UNITED STATES PATENT AND TRADEMARK OFFICE

APPLICATION NO.	FILING DATE	FIRST NAMED INVENTOR	ATTORNEY DOCKET NO.	CONFIRMATION NO.
10/759,013	01/20/2004	Kiyoyuki Narimatsu	118380	6832
25944	7590	03/21/2006	EXAMINER	
OLIFF & BERRIDGE, PLC P.O. BOX 19928 ALEXANDRIA, VA 22320			TOTH, KAREN E	
			ART UNIT	PAPER NUMBER
			3736

Office Action Summary

DETAILED ACTION

Figure 1.
Figure 1 of Narimatsu Application No.
10/759013, showing "handle portion" 12.

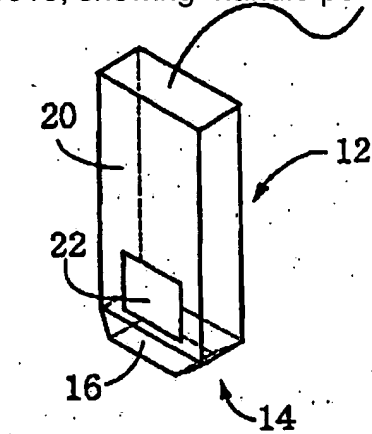
Regarding Claim 3, Archibald'022 in view of Asmar'107 teaches all the elements of the current invention except for the probe comprising a handle portion that is integral to the sensor portion and designed to be held by an operator.

Archibald'022 further teaches that said pressure sensor is contained within a main housing (element 140) that is designed to be held by the user when in use (column 3, lines 12-14). See figures 1 and 2 below.
